County of Fairfax, Virginia

STAFF REPORT

APPLICATION SE 2010-LE-025

APPLICANT: Costco Wholesale Corporation

LADSON LANE (SECTION B-B)

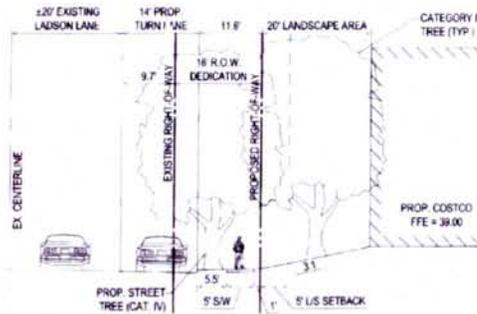
Cross-section B-B on Sheet 12 shows the vegetated swale to be a range of 5 to 20 feet wide. To meet the design criteria of PFM 6-1308 in the site plan submission, the minimum width of the swale is likely to be greater than 5 feet.

TRUCK TURN PLAN

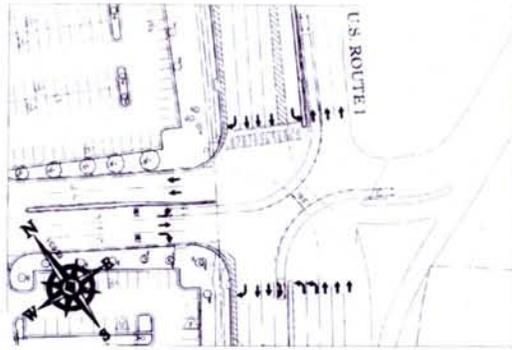
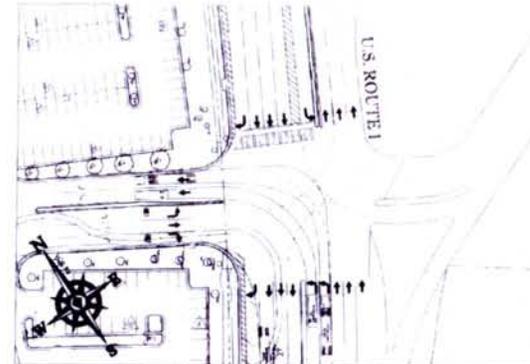
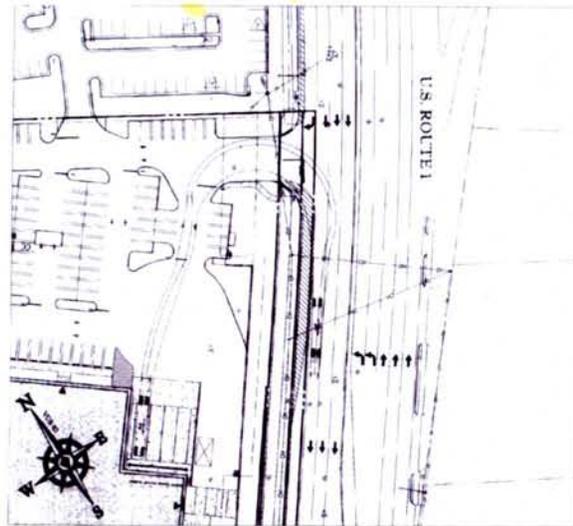
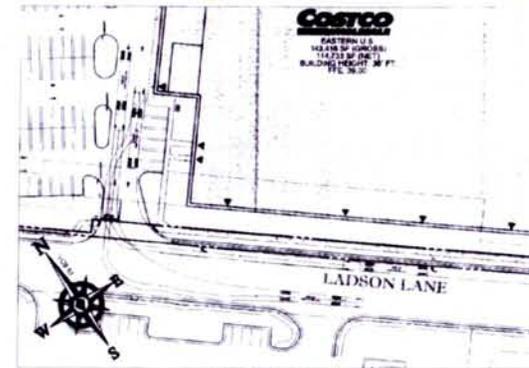
- Show the truck turning movements between the loading docks and Route 1 for arriving and departing trucks. Although this is shown on Sheet 11, it is not very legible and the applicant has agreed to provide a more clear drawing.

5 VIEW FROM MOBILE HOMES

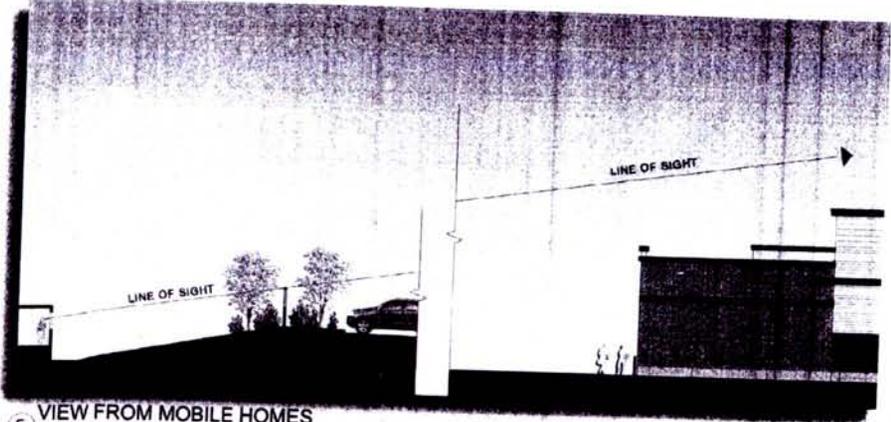
OCRR staff expressed the same concerns as those discussed under the Land Use Analysis section earlier in the report regarding inadequate buffering to the rear of the property along the western and southern property lines and the need to fully screen the loading area along Richmond Highway. OCRR staff also suggested that the applicant reduce the number of proposed parking spaces, provide architectural renderings which demonstrate that roof top mechanical equipment is not visible, and provide architectural interest along the Richmond Highway frontage.

The applicant increased the buffering along the western property line to include 15 large deciduous trees, 35 large evergreen trees, 40 medium size evergreen trees, and 161 medium size evergreen shrubs. The applicant is also proposing to provide the required amount of streetscaping along Ladson Lane. The applicant also reduced the number of proposed parking spaces from 588 to 575 spaces. Architectural renderings have been provided; however, the applicant has not yet provided a rendering which demonstrates that mechanical rooftop equipment is fully screened from view. Therefore, staff has proposed a development condition to address this concern.
